# Mt Messenger Bypass

Review of Landscape, Natural Character and Visual Impact documents

Review Undertaken for NPDC by Richard Bain Landscape Architect

#### **RE: MOUNT MESSENGER BYPASS - LANDSCAPE MATTERS**

Northbound approaching first cut series in the south of the project (Mimi Valley) with existing SH3 aliognment (and bench) in red.

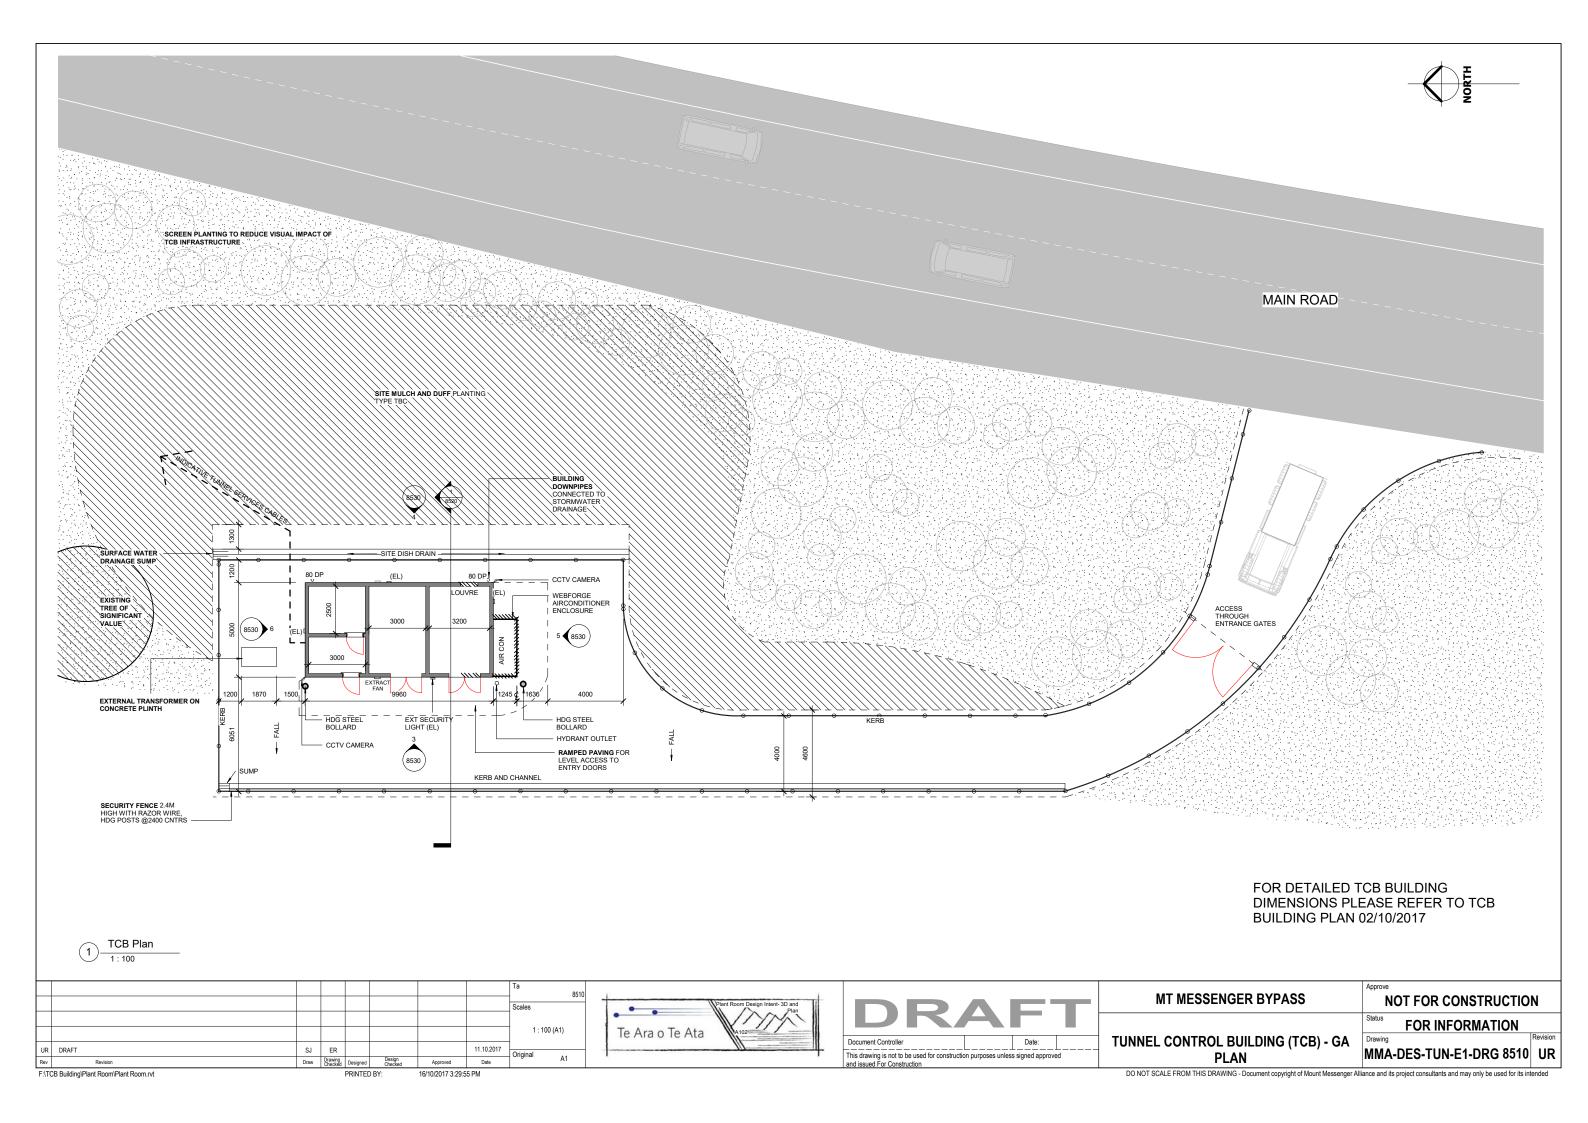
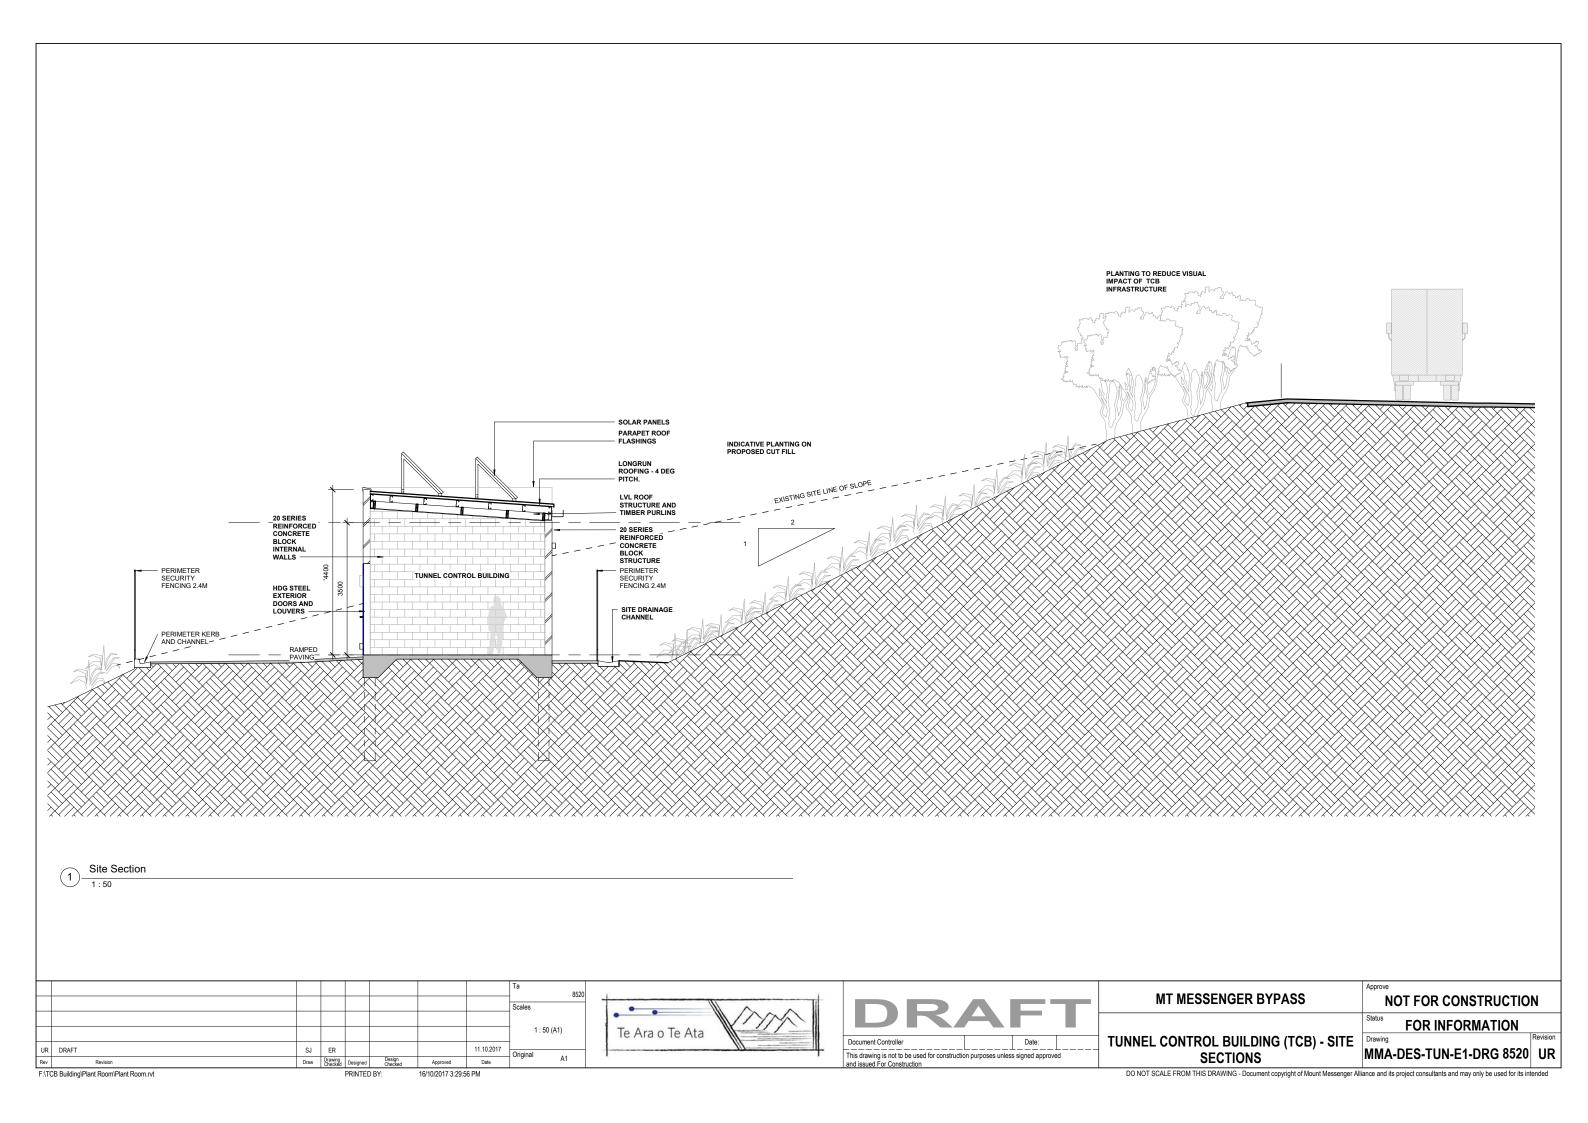
Overall, the information looks very fit for purpose. My only real specific concern is the same as yours as articulated on page Page 37

"However, the cut and fill batters are arguably the most prominent element of the highway with the potential to detract from the surroundings and user experience. They therefore warrant particular attention."

I think that's right – I'm comfortable with these however given the scale of the surrounding landscape (very steep terrain in parts with strong contrasts in elevation – see additional examples below. This natural terrain and hill country environment contextualise the cuts. In detail design we'll look to eliminate or reduce the downslope cut remnants where we can as much as possible to leave the immediate downslope side tidy (i.e. not have a run of small *disconnected* 'left overs'. In general the steeper cuts angles mirror the larger spurs that they are *connected* to. The chosen alignment helps in this regard.

Richard - I've attached a couple of further Model Screen Shots for your info below.

**TUNNEL CONTROL BUILDING (TCB) -ELEVATIONS**

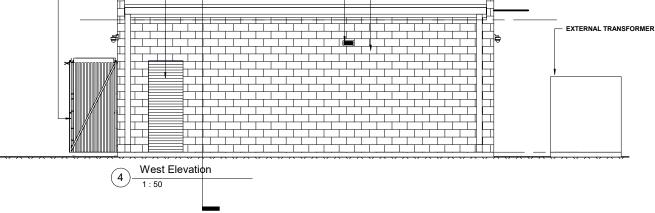
2. Some of the structures such as the tunnel control building and fire water tanks are shown only very conceptually. Has further design work be undertaken on these structures to give us a better idea of their visual impact?

We have been doing some additional design work on the TCB in particular – plans attached. The Hydrant tank option is as proposed.
